312 Lisgar Street

Urban Design Brief
June, 2025

Response to Urban Design Comments

This section provides a response to comments received from Urban Design staff on January 14, 2025, following the pre-consultation meeting held on January 7, 2025.

Elevations

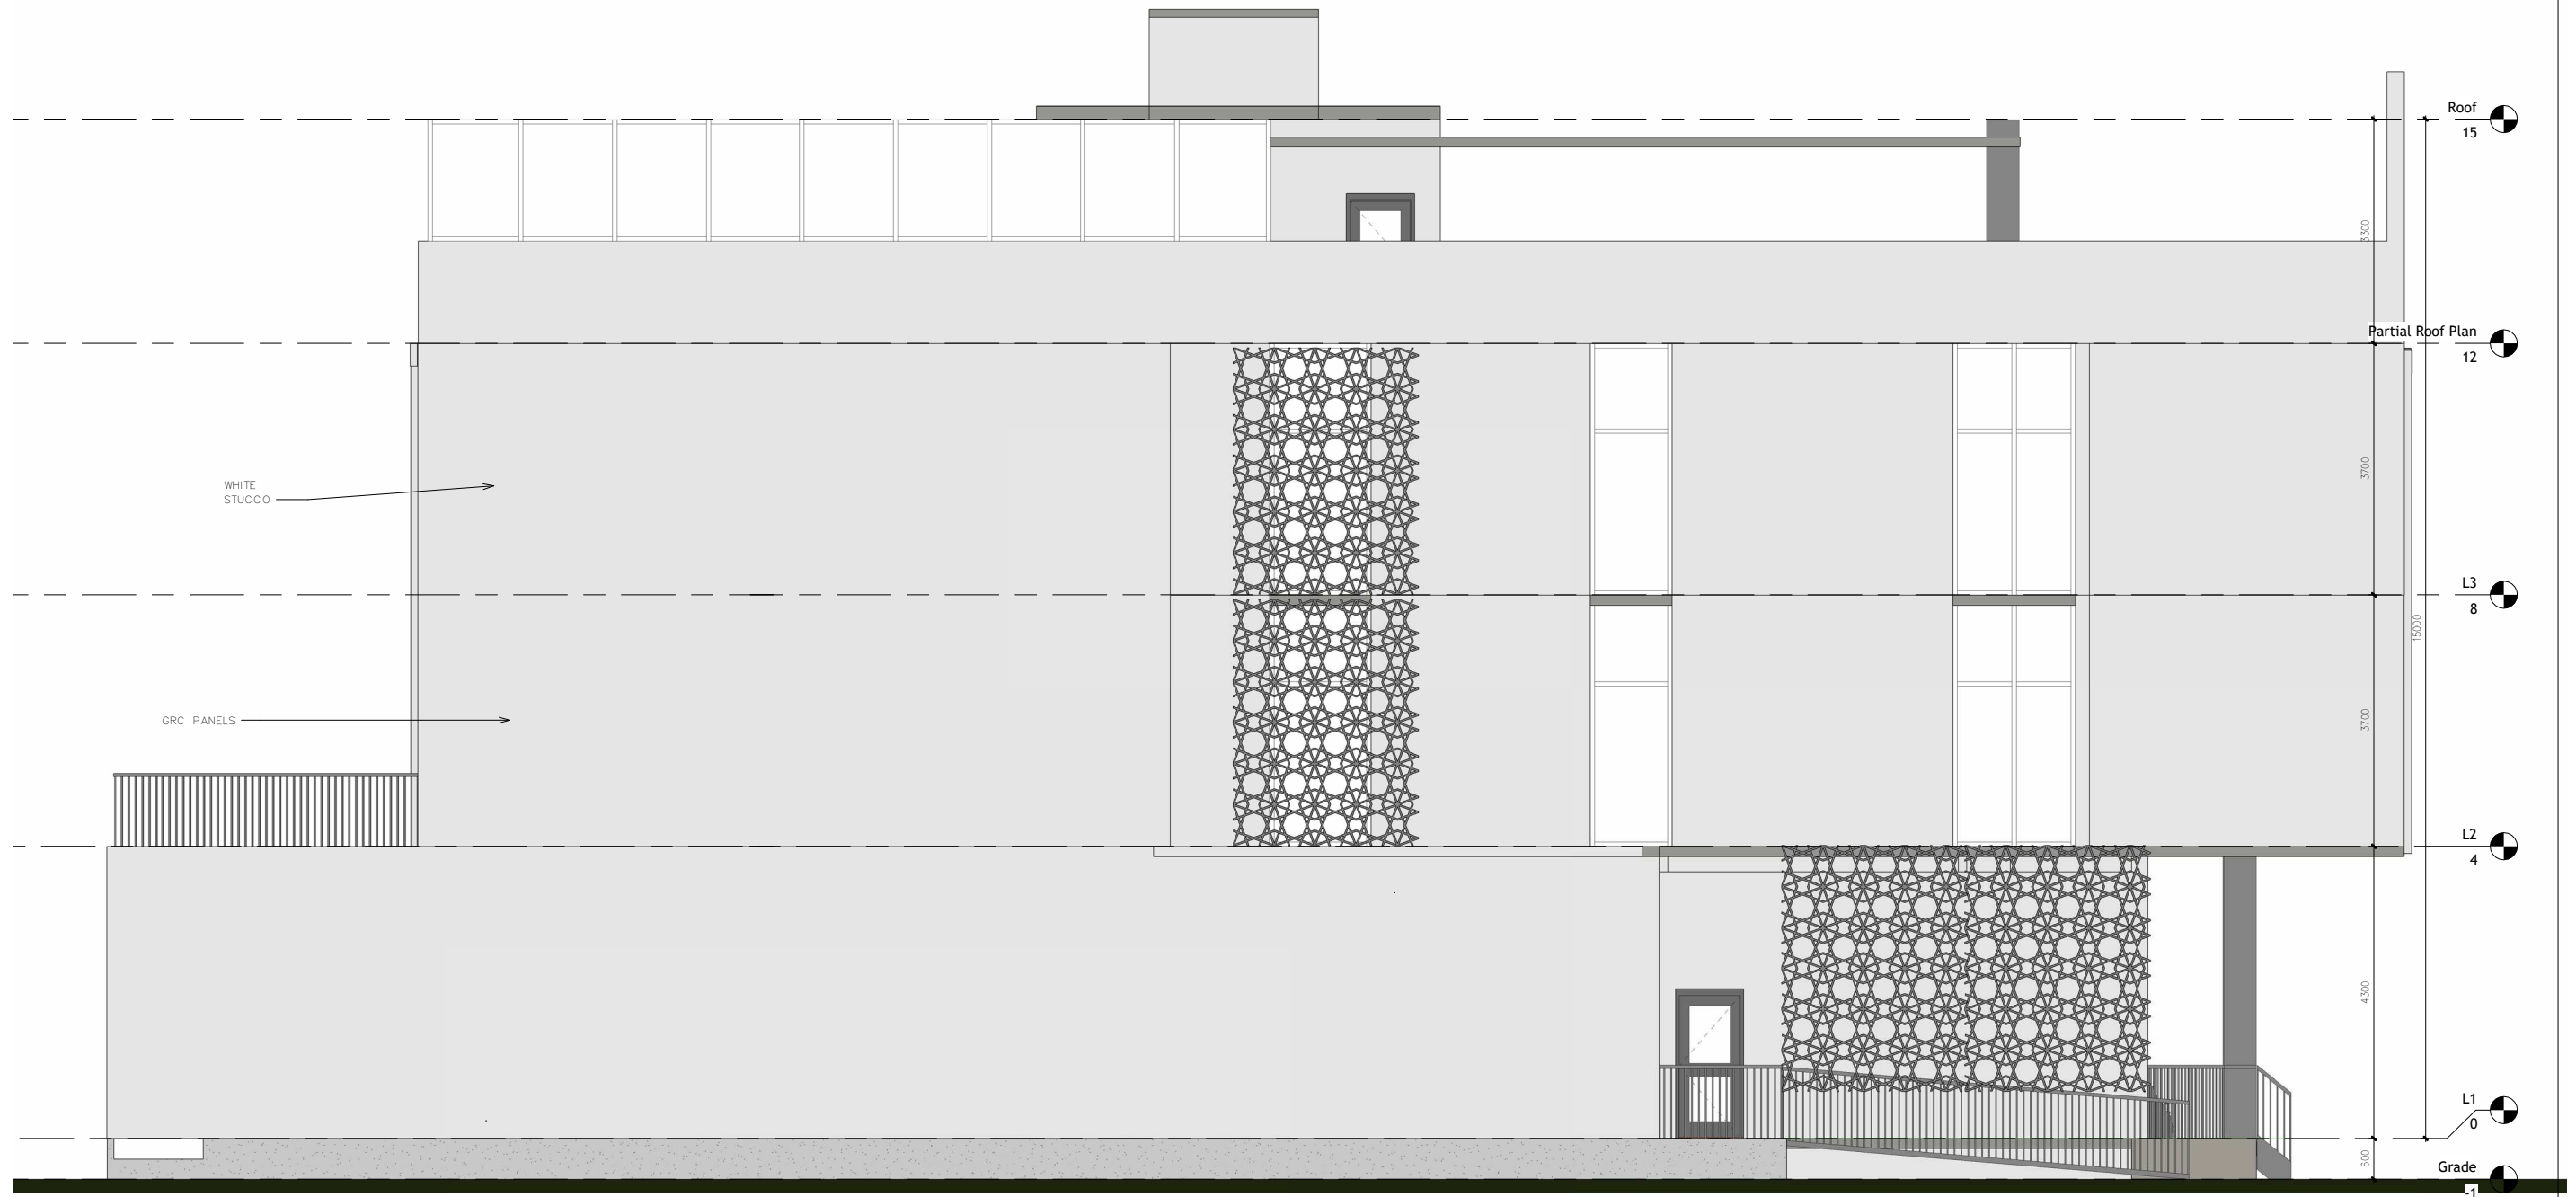
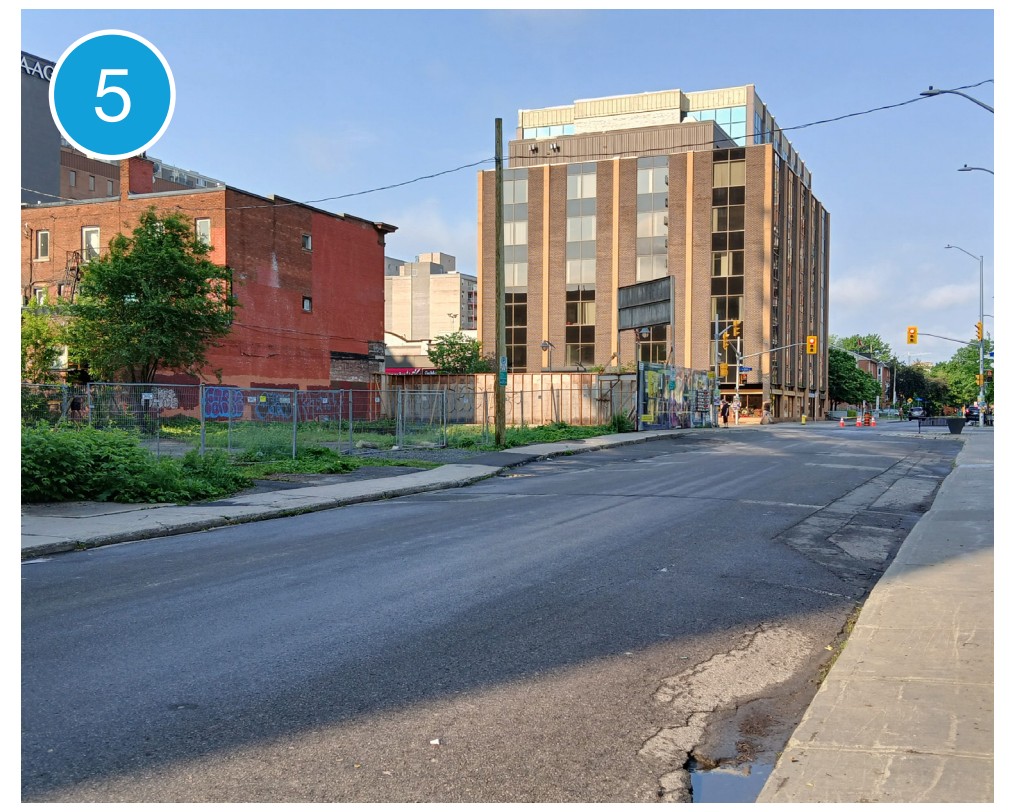
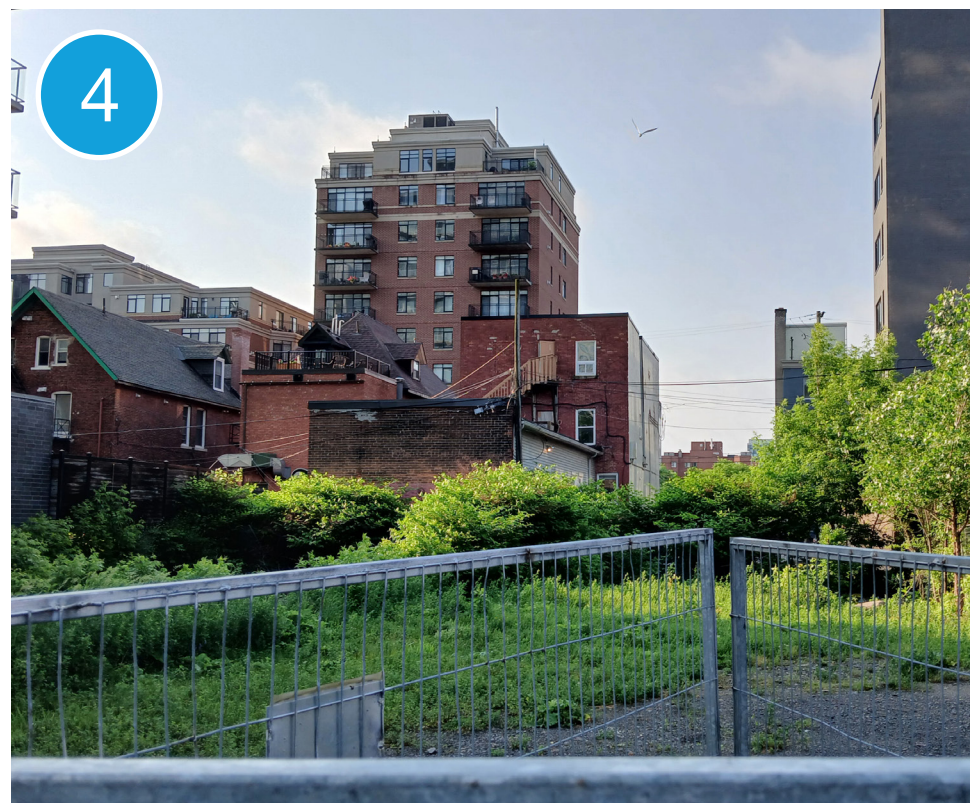
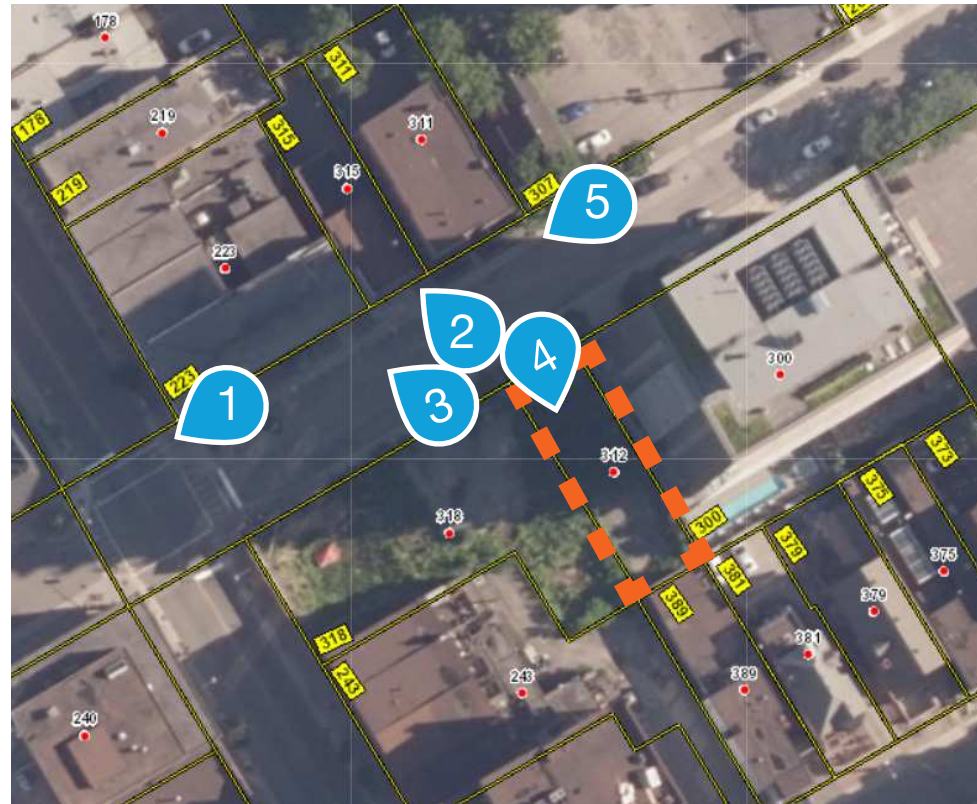
City Comment 11. Staff are generally supportive of the 5 storey built form but have questions regarding phasing and the overall aesthetic of the building if the top 2 storeys are constructed at a later date. Please provide detailed Building Elevations and a phasing strategy.

Response: Please see the building elevations included in the submission package and on pages 8-10 of this Urban Design Brief. A three storey built form is proposed.

City Comment 13. With the minimal side yard setbacks proposed, please ensure that the blank wall conditions contain murals or some form of architectural treatment.

Response: Decorative panels are proposed on the east and west facade to add visual interest along the blank walls. The ground floor is animated with transparent glazing and the upper floors are articulated with windows.
